Reliability Analysis Update

Sub Regional RTEP Committee - PJM West

June 15, 2021

Changes for Existing Projects

B2334 Cancellation

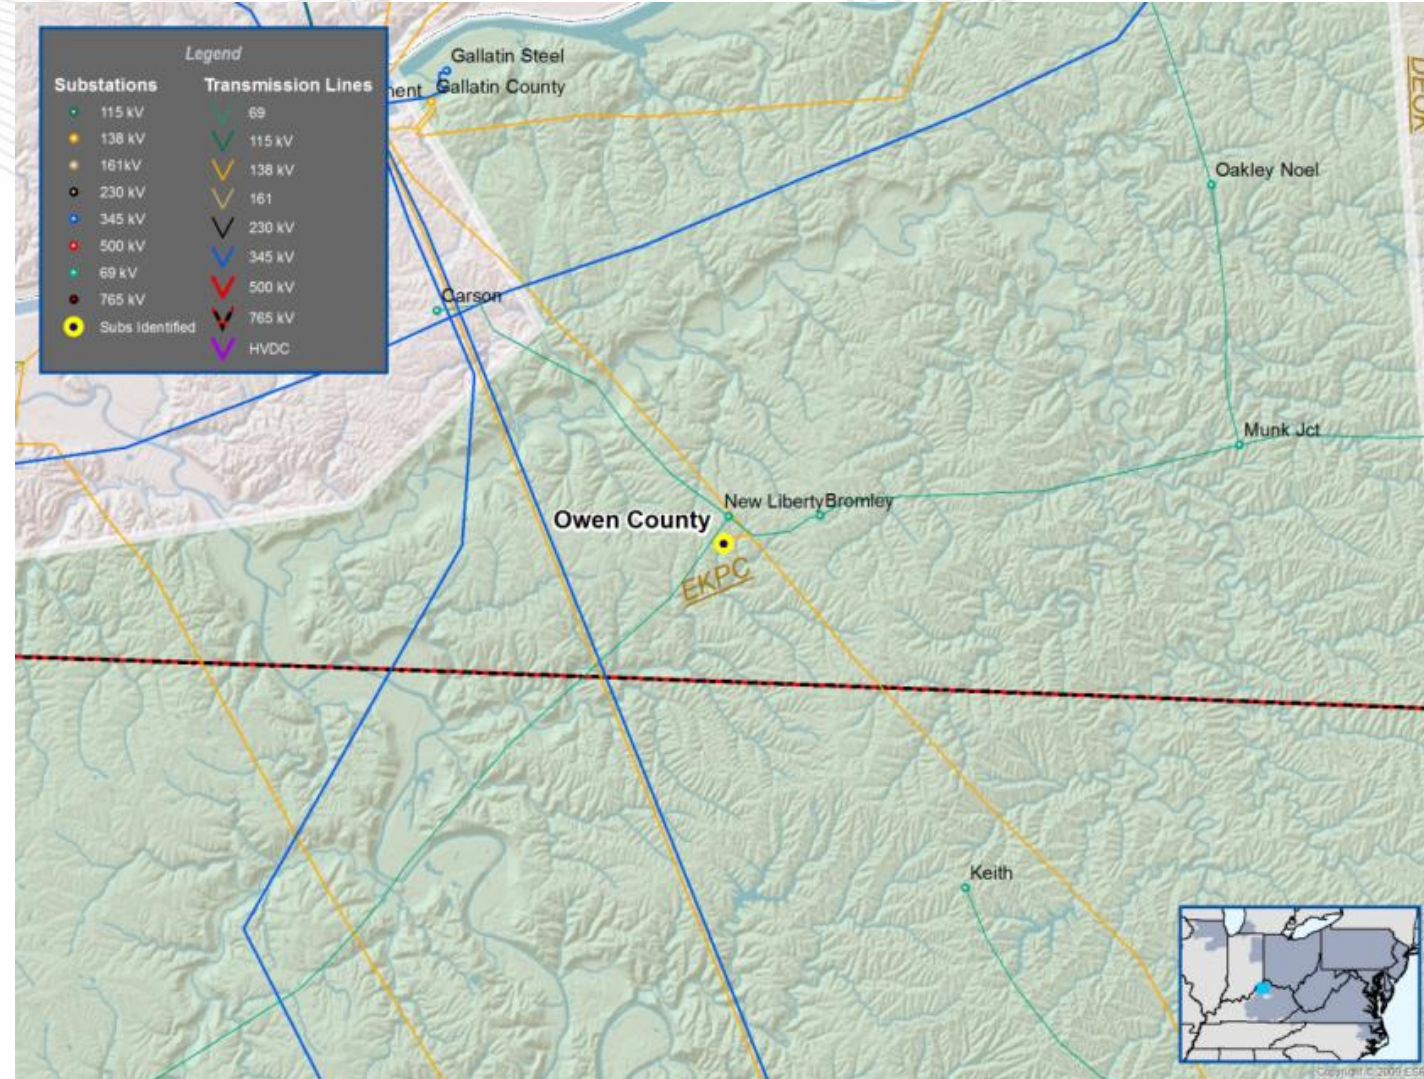
Low voltage at the Keith and Clay Village 69 kV buses during an N-1 outage.

Install a 69 kV, 28.06 MVAR capacitor bank at the Owen County substation. **(B2334)**

Reason for cancellation:

EKPC's 2020 screening results show that the need for this project has been pushed beyond 7 years. There has been multiple case changes that contributed to the need being pushed back, including load forecast updates in the area and nearby transmission system upgrades outside of PJM.

B2783 Cancellation

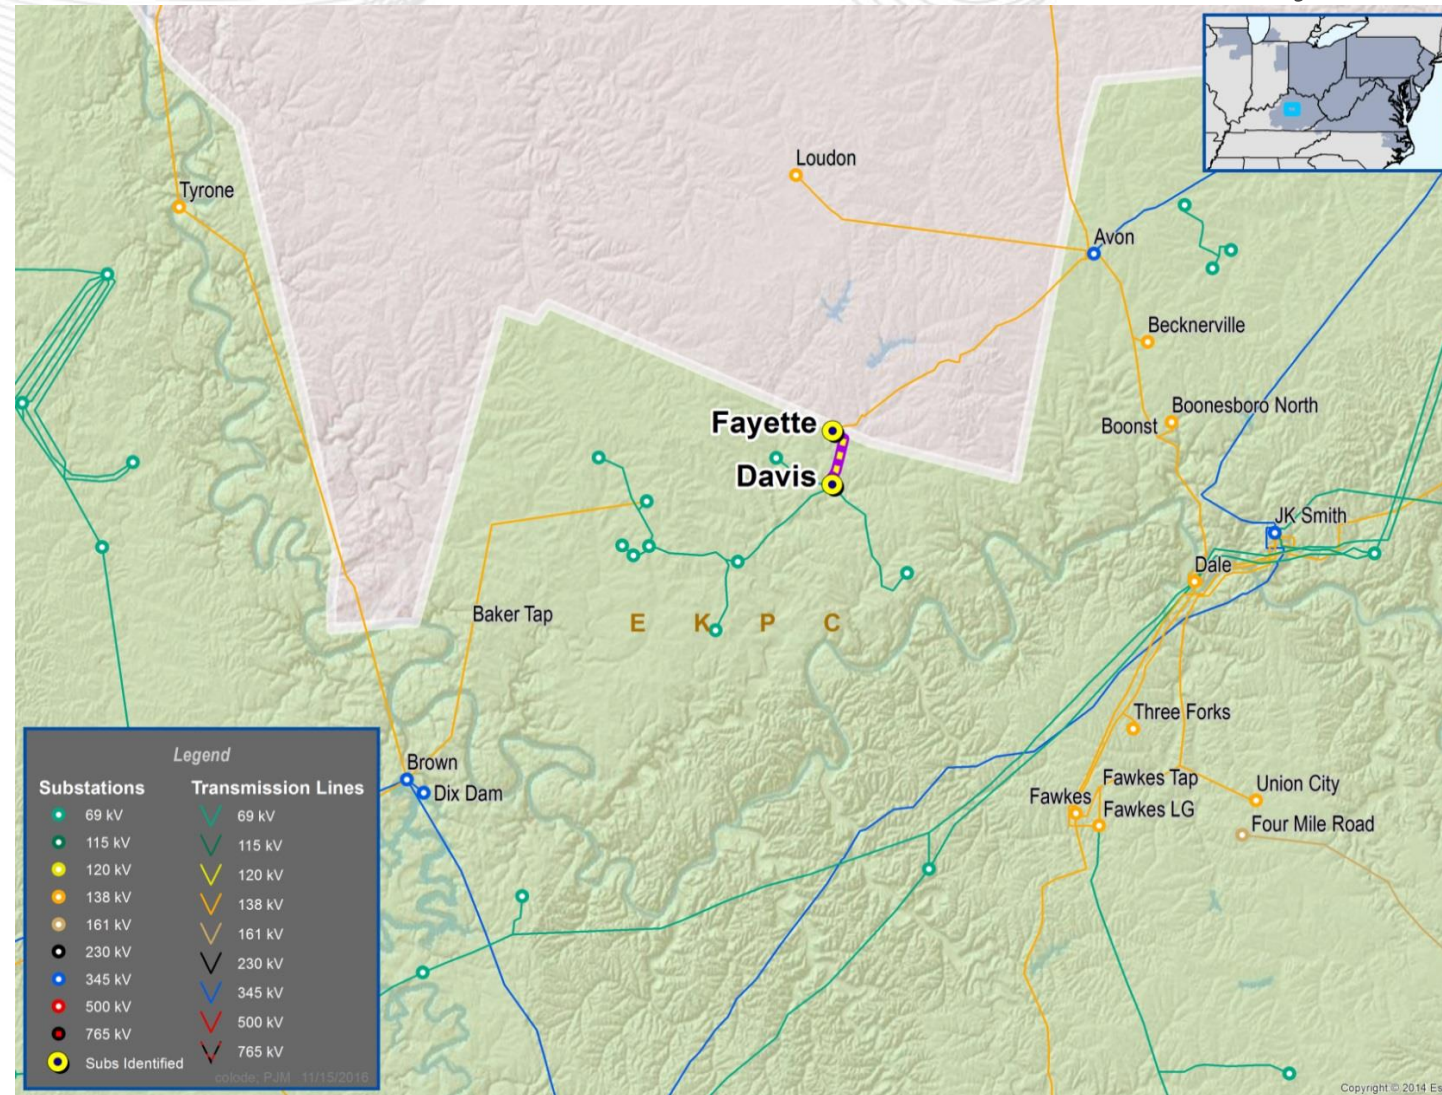
The Davis-Fayette 69 kV line is overloaded for an N-1 outage.

Rebuild the Davis - Fayette 69kv line section to 556.5 MCM (3.15 miles) **(B2783)**

Reason for cancellation:

EKPC's 2020 screening results show that the need for this project has been pushed beyond 7 years due to load forecast updates in the area.

B2915 Cancellation

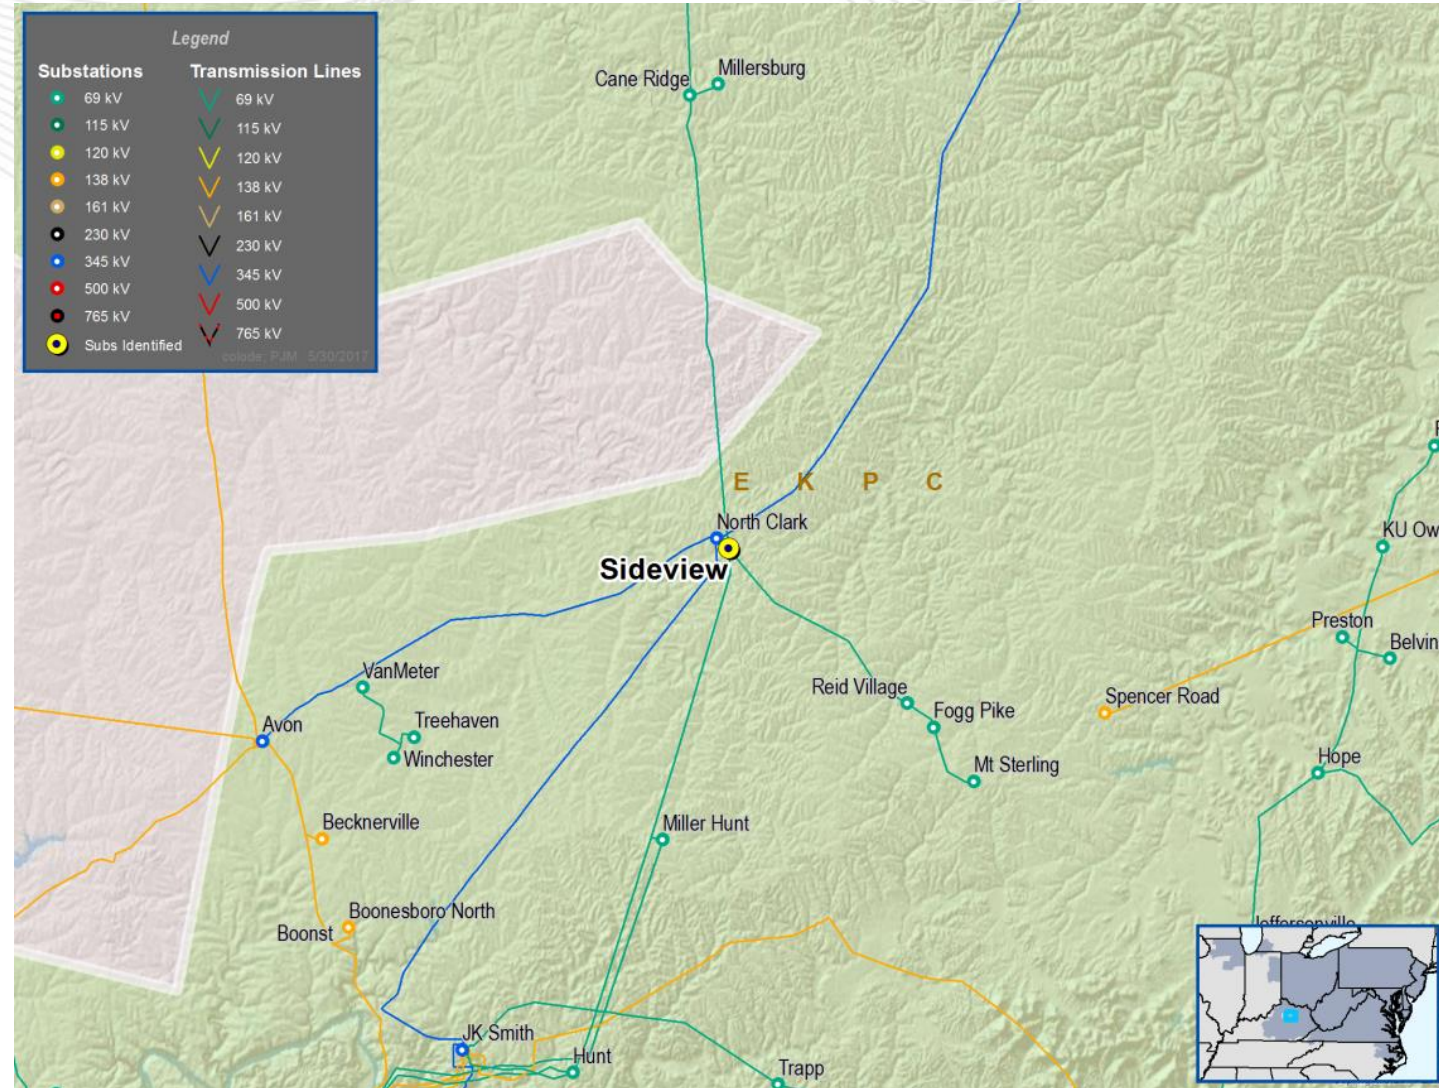
Low voltage at the Mt. Sterling substation for an N-1 outage.

Resize the Sideview 69 kV capacitor bank from 6.12 MVAR to 9.18 MVAR. **(B2915)**

Reason for cancellation:

EKPC's 2020 screening results show that the need for this project has been pushed beyond 7 years due to load forecast updates in the area.

B3045 Cancellation

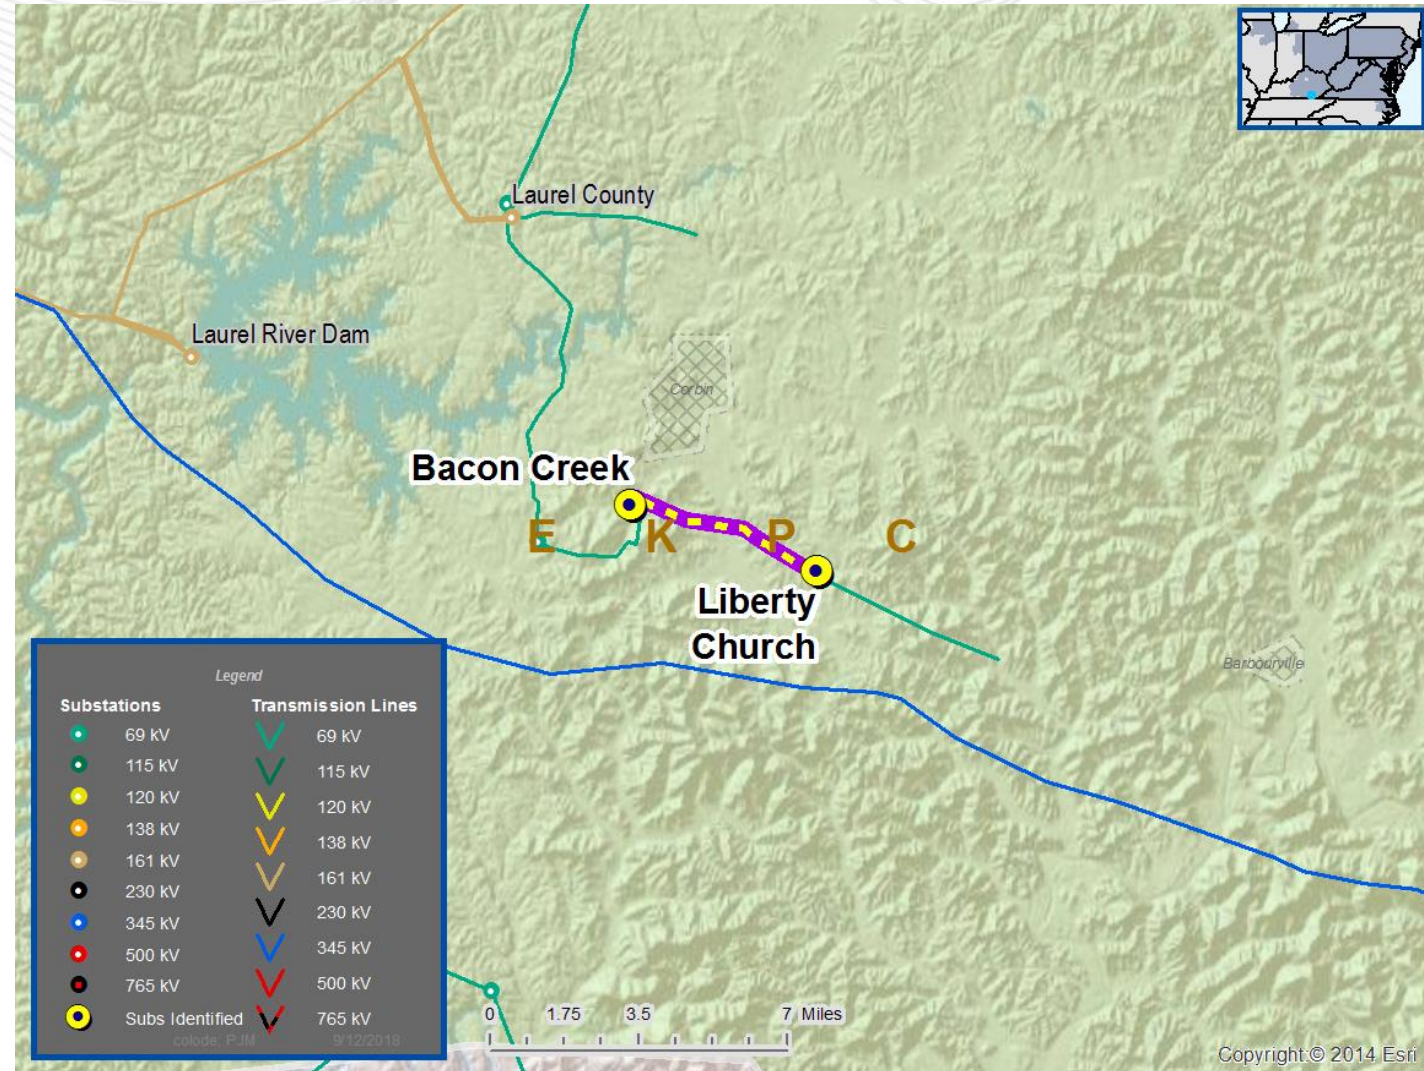
The Liberty Church Tap-Bacon Creek Tap 69 kV circuit is overloaded for an N-1 outage.

Increase the MOT of Liberty Church Tap-Bacon Creek Tap 69 kV line 266.8 MCM conductor from 212° F to 266° F. **(B3045)**

Reason for cancellation:

EKPC's 2020 screening results show that the need for this project has been pushed beyond 7 years.

B3046 Cancellation

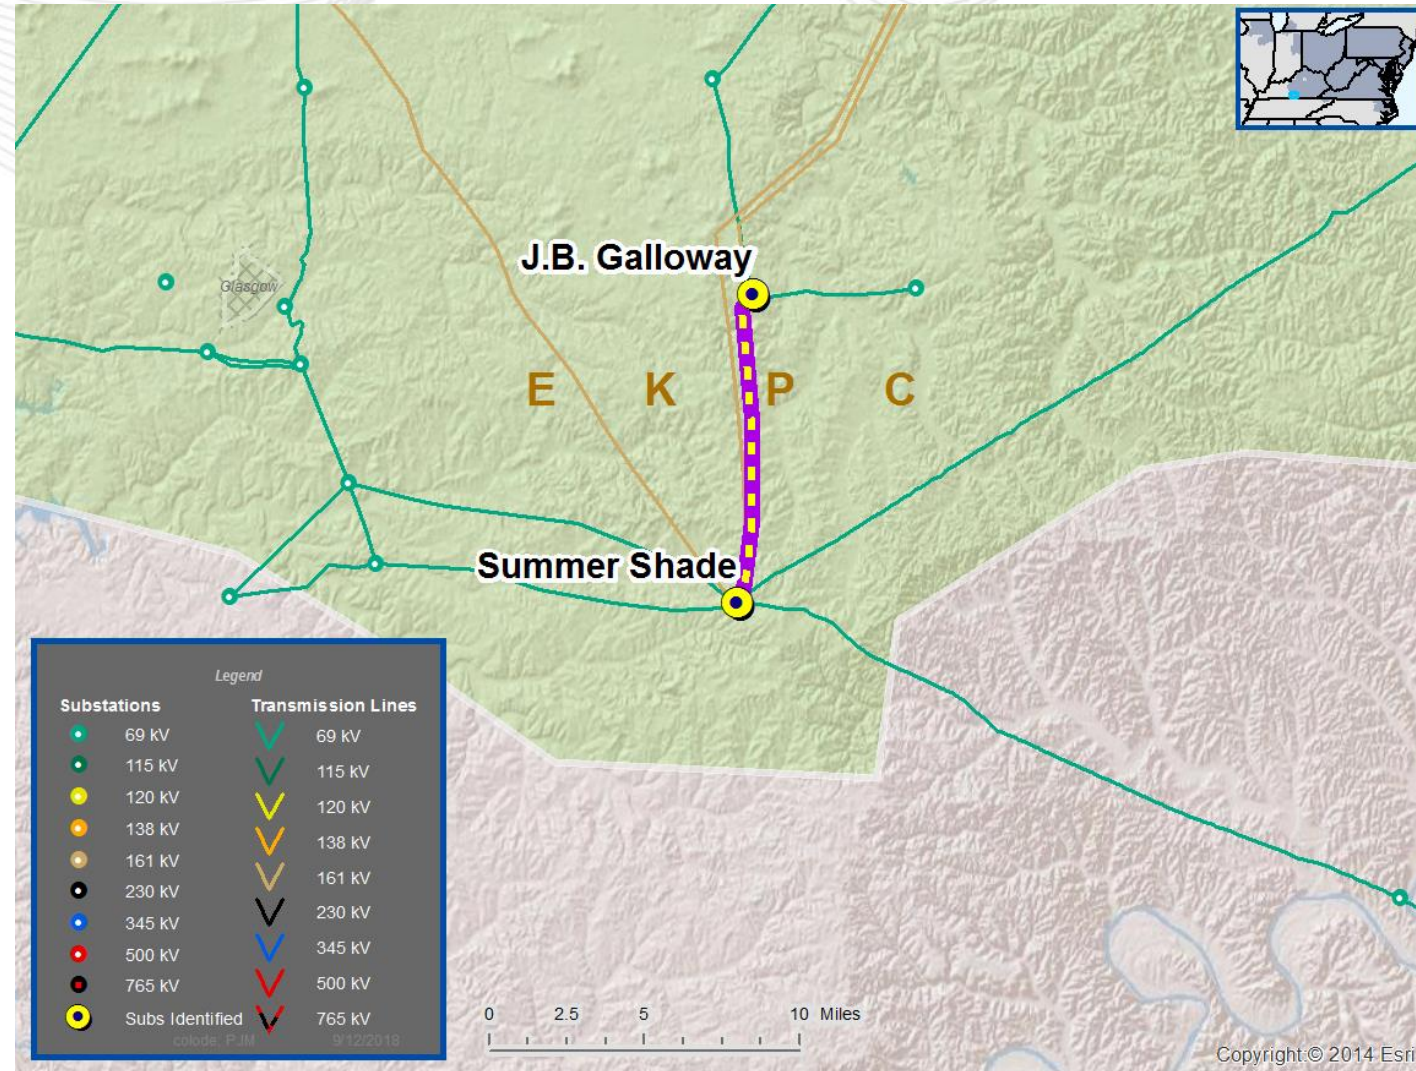
The Summer Shade-JB Galloway Jct. 69 kV line is overloaded for an N-1 outage.

Increase the MOT of Summer Shade-JB Galloway Jct. 69 kV line 266.8 MCM conductor from 167° F to 212° F. **(B3046)**

Reason for cancellation:

EKPC's 2020 screening results show that the need for this project has been pushed beyond 7 years.

Project cost change for B2611.1-.2 (Presented in 1/7/2015 TEAC)

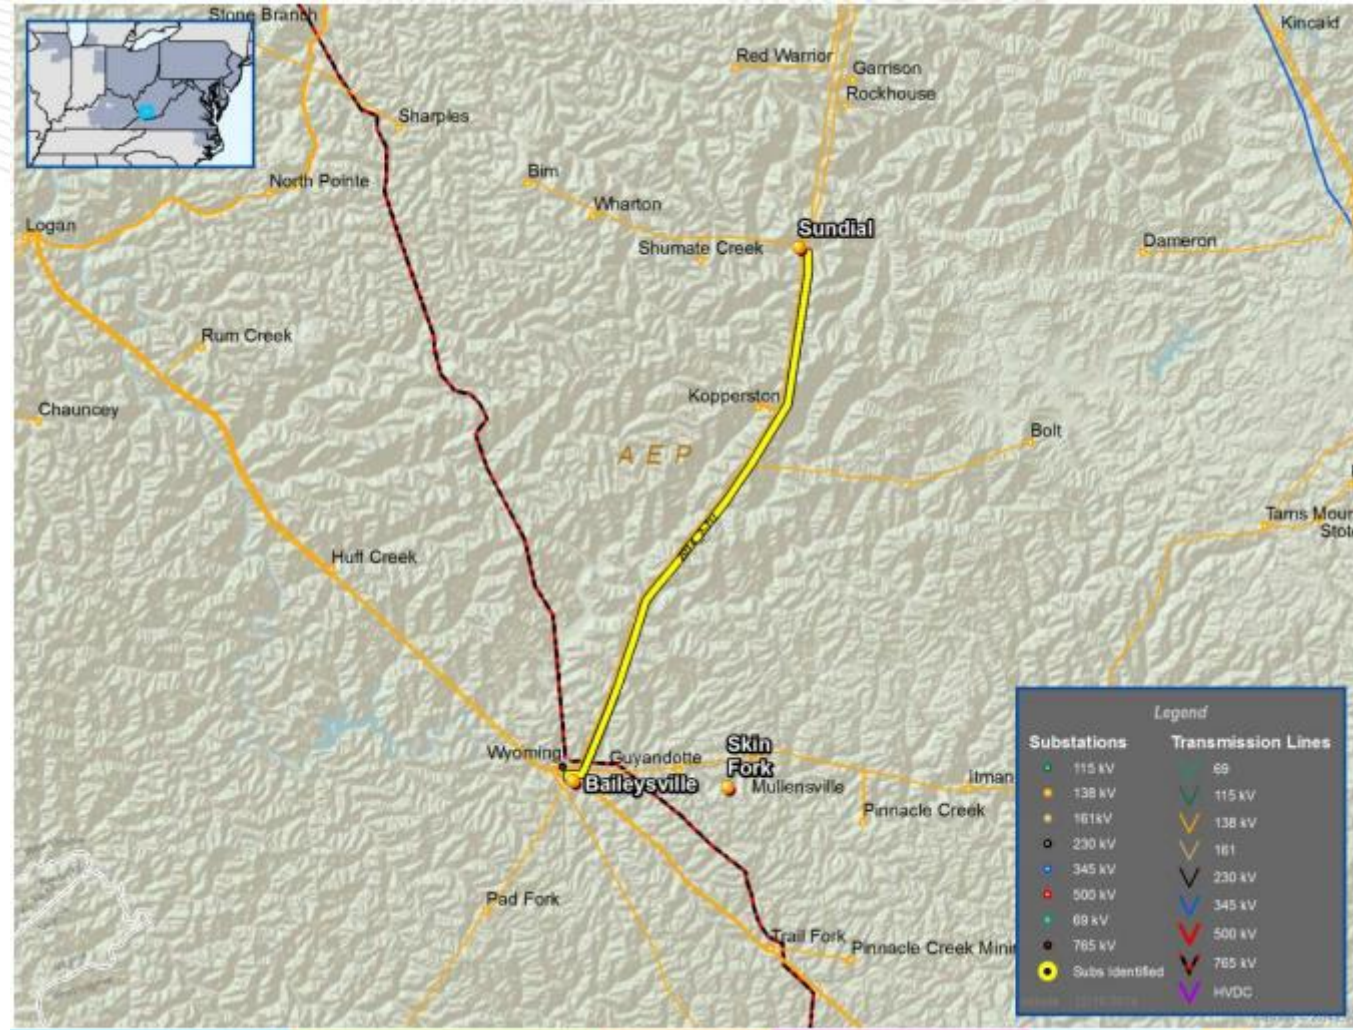
B2611.1-.2 was in 2014 RTEP window #2. It was proposal P2014_2-2U, which was the only proposal received to address the AEP 715 violations on the Becco – Latrobe 46kV line overloads and low voltage issues at the Toney Fork, Cyclone, Latrobe, Craneco S. S. 1, Craneco S. S. 2, Pardee S.S., Three Forks, 46kV buses and Chap 69kV bus.

- Install a new 138/46 kV station near Skin Fork (B2611.1)
- Construct 3.2 miles of 1033 ACSR double circuit from New Station to cut into Sundial-Baileysville 138 kV line; Build 0.5 795 ACSR 69kV standards (operated at 46kV) line to Skin Fork station from the New Station; At Skin Fork, install a Breaker on new line exit towards New Station and circuit switcher on 46/12 kV transformer; At Becco, Install a circuit switcher on 46/12 kV transformer; Rebuild 3.57 mile section of Becco - Latrobe 46kV line with 795 ACSR built to 69kV standards (operated 46kV) (B2611.2)

Major Reasons for Cost increase (B2611.1-.2):

- Due to the complexity of the project and difficult terrain, construction bids came in higher than original estimates.

- Delay due to inability to secure required easements through the condemnation process in time for work to continue without demobilization. Costs encompass remobilization and some temporary work to keep line in service during delay. An additional complication was added with the closure of WV courts in response to the COVID pandemic.

- Encountering excessive access road rock & excessive rock drilling costs above anticipated amounts based on available soil borings.

- WVDEP requirement on enhanced SWPPP including increased inspection intervals and enhanced environmental barriers. Recent change to state regulations.

- Non-topology changes identified in detailed design to Station scopes for the remote end stations resulted in additional costs at Baileysville and Chauncey. These changes include relay panel changes, the addition of SST/CTs/CCVTs, rock adders and scope for testing and commissioning.

- Non-topology changes identified in detailed design to Line scopes resulted in additional costs that include alignment shifts, changes in foundation designs, distribution relocations, steel tariffs, and bat studies.

New Estimated Project Cost: \$60.1M
